**PLANNING AND ZONING COMMISSION
REGULAR MEETING
AGENDA**

Wednesday, February 12, 2020

Manor City Hall – Council Chambers
105 E. Eggleston Street

OPTION - 3

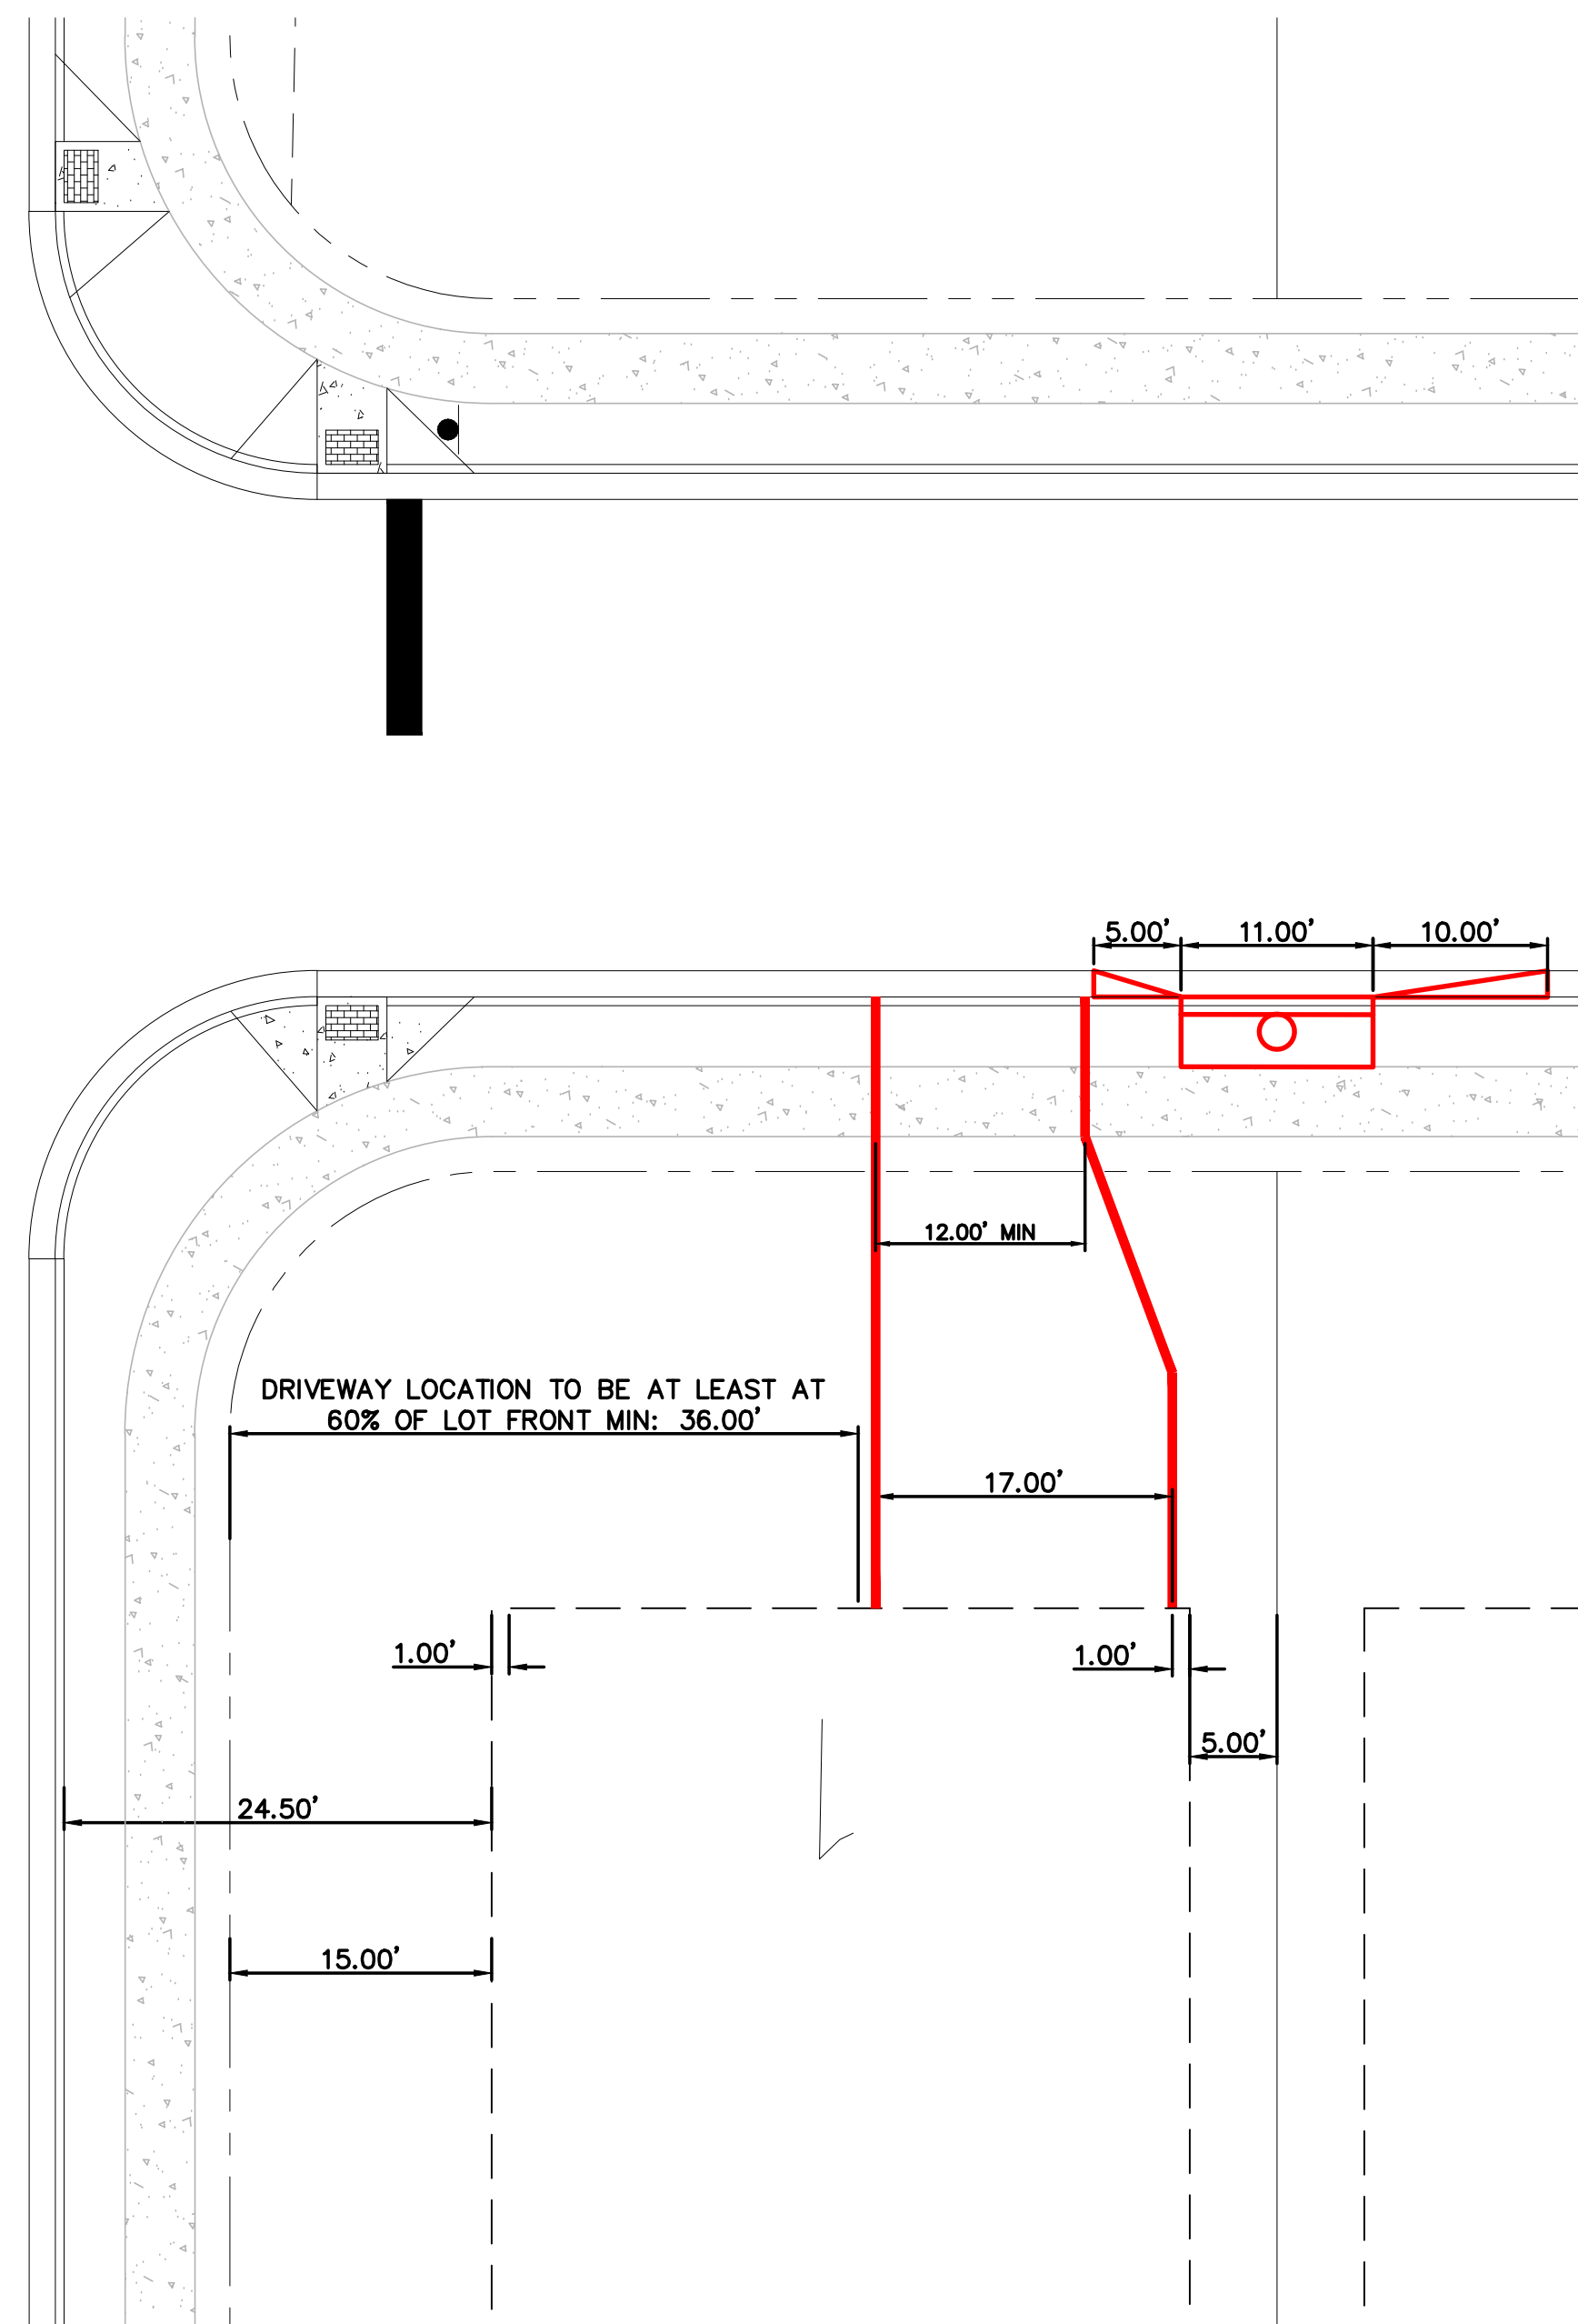
Thank you for the update. The driveways proposed address our concerns. Please make sure you sign and seal these sheets. You should also revise the Section 17 construction plans to note the 5 foot transitions on the appropriate inlets so that there is not an issue when Travis County accepts the streets.

Attached are the exhibits with the 12 ft of minimum width. The "wings" on the driveway apron were taken from the detail of City of Manor and on measurements of the existing driveways.

GRADING & DRAINAGE PLAN

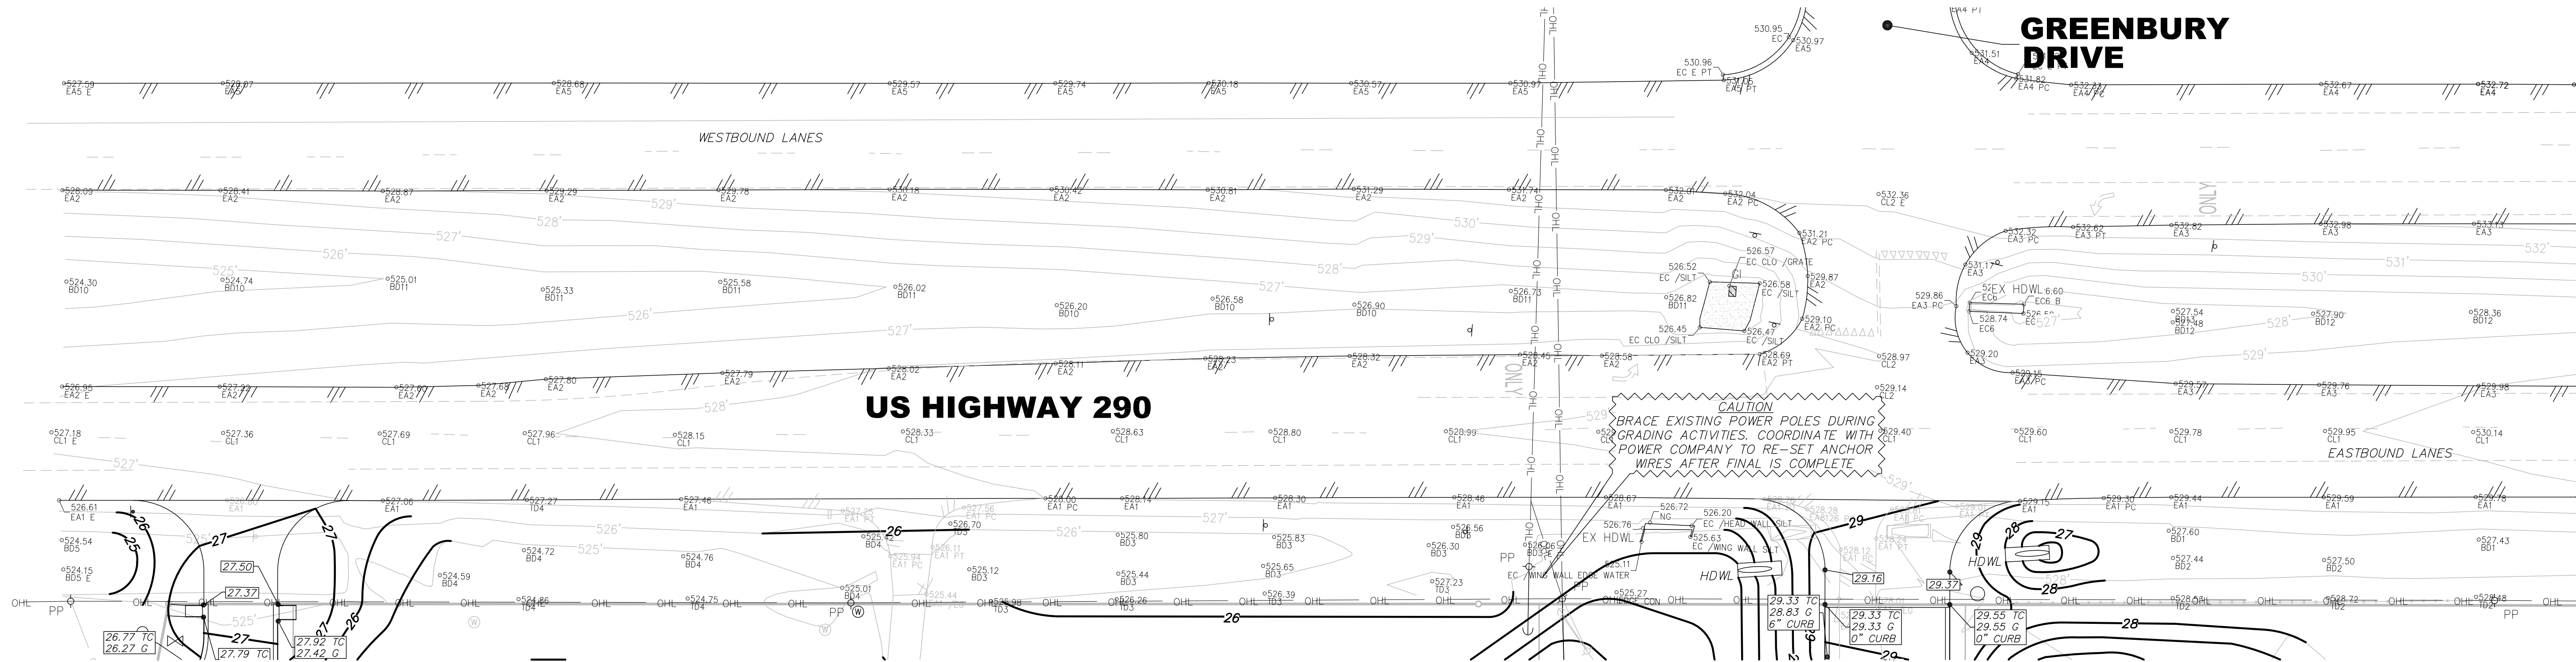
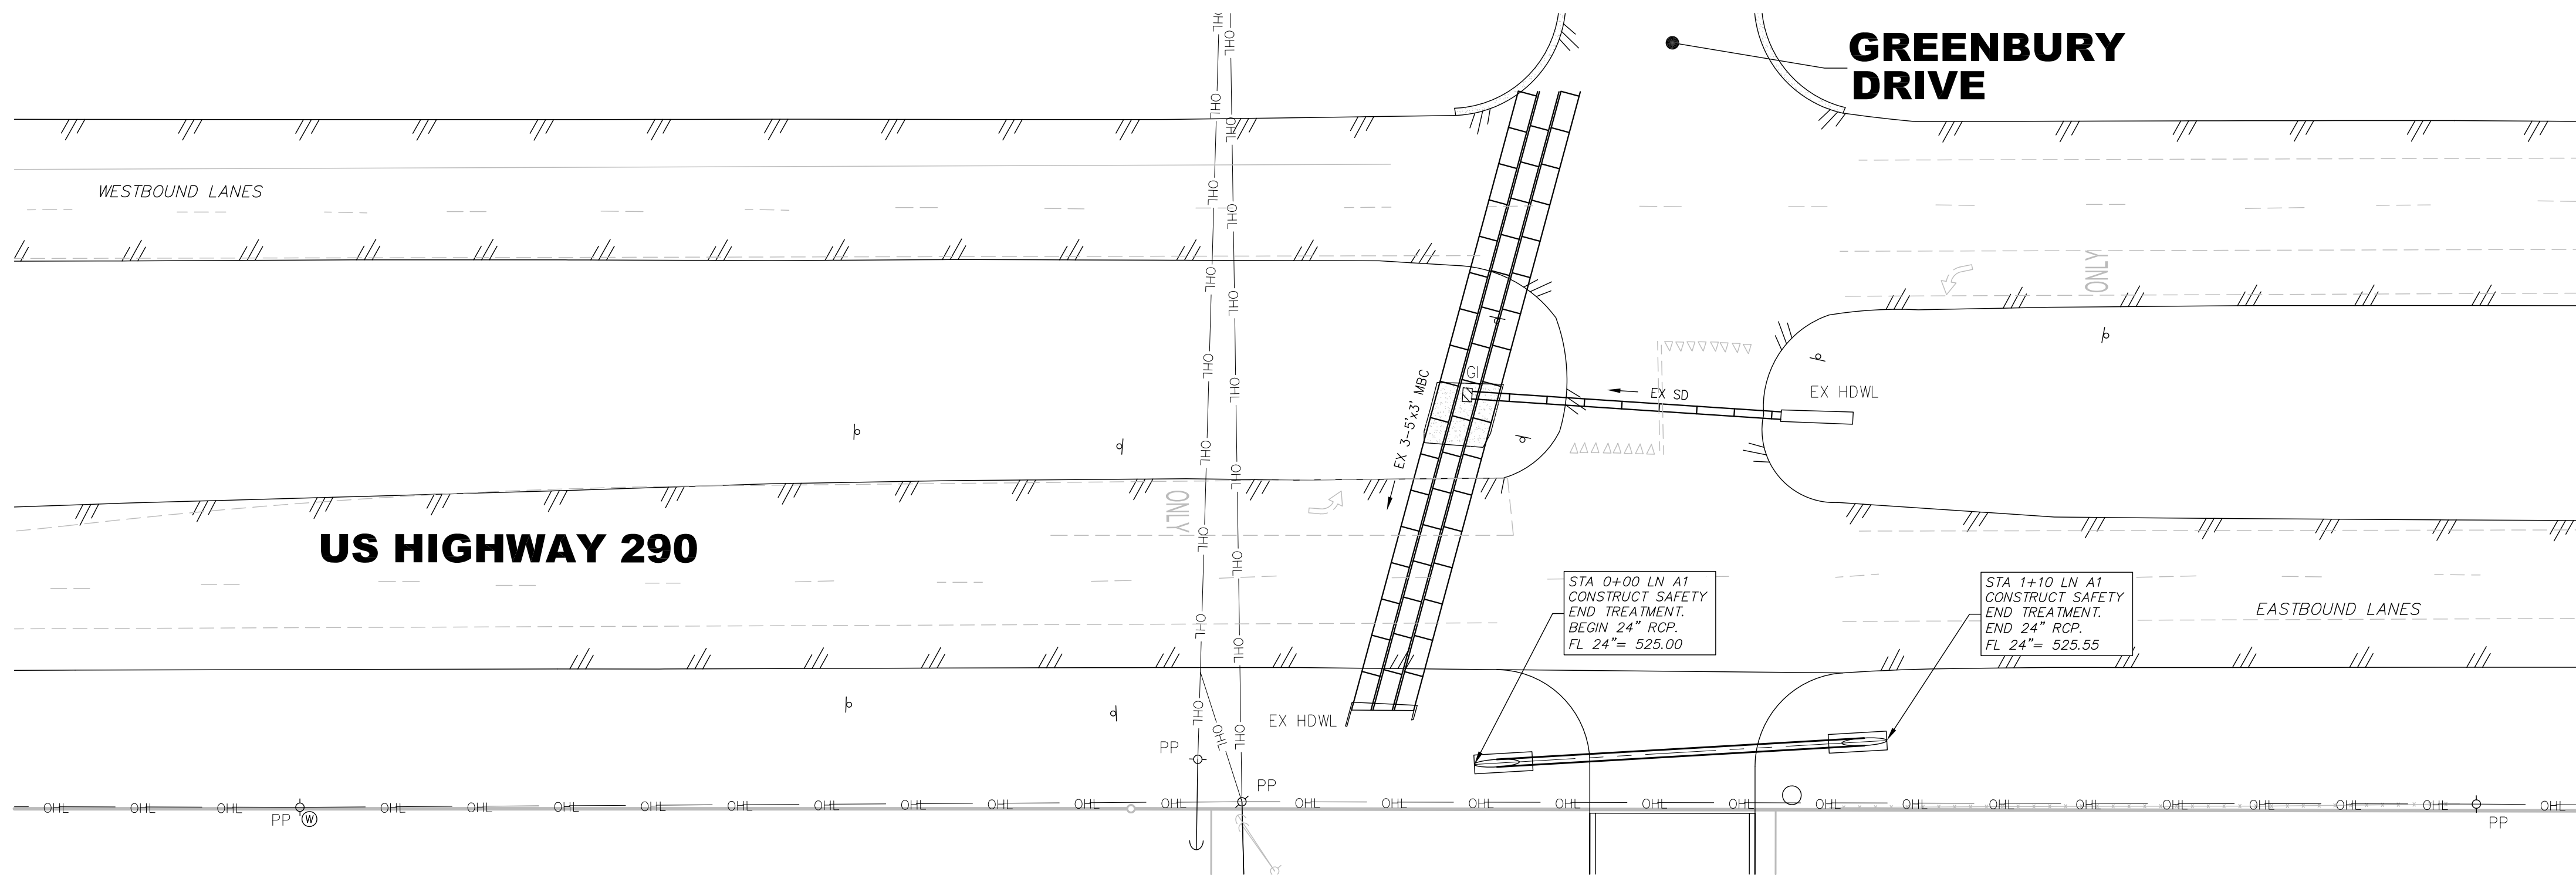
- 2) An existing 3-5'x3' box culvert runs underneath the US 290 pavement and discharges at the site's northern boundary. Any sidewalk not adjacent to the pavement would have to be within the runoff conveyance area and pedestrians would be subject to high flows and/or debris left on the sidewalk. We have spoken to the Texas Department of Transportation, and they have directed us to avoid making any modifications to the existing drainage structures.

This request is not to remove the sidewalk requirement along US 290, but to defer construction of that sidewalk until Lots 1 and 2 develop. Upon development of those lots, alternative sidewalk locations can be studied and a solution presented to the City. The proposed driveways to be built with the current, Lot 3, development have been designed to accommodate a pedestrian crossing and no modifications are expected when sidewalks are constructed at a future date.
